**Source:** ITU-T Study Group 15

**Title:** Request for clarification concerning MPLS-TP shared ring protection

**LIAISON STATEMENT**

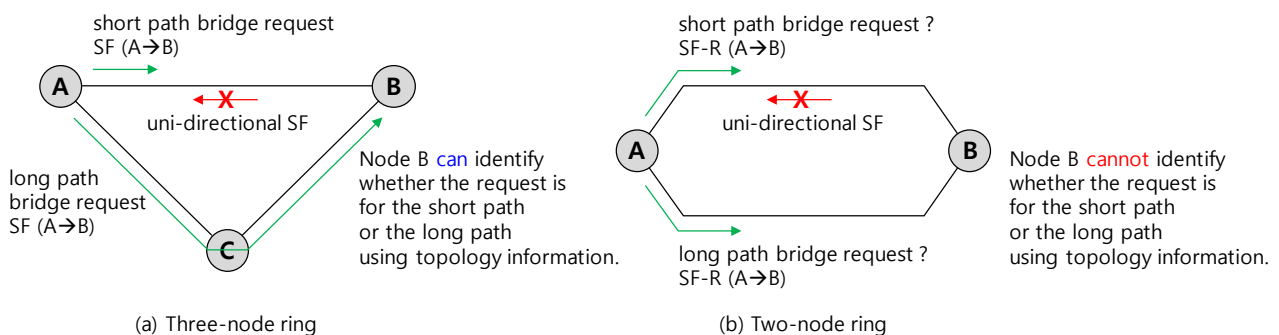
This text clearly indicates that a two-node ring should be possible. However, the protocol specified in RFC 8227 specifies behaviour in the event of a unidirectional failure that requires a destination node to be able to distinguish the long path from the short path when responding to RPS signalling. In a two-node ring, it appears to be not possible for the destination node to make this distinction. The figure below illustrates the scenario in question.

We would appreciate clarification of the expected behaviour in the configuration (b) above.
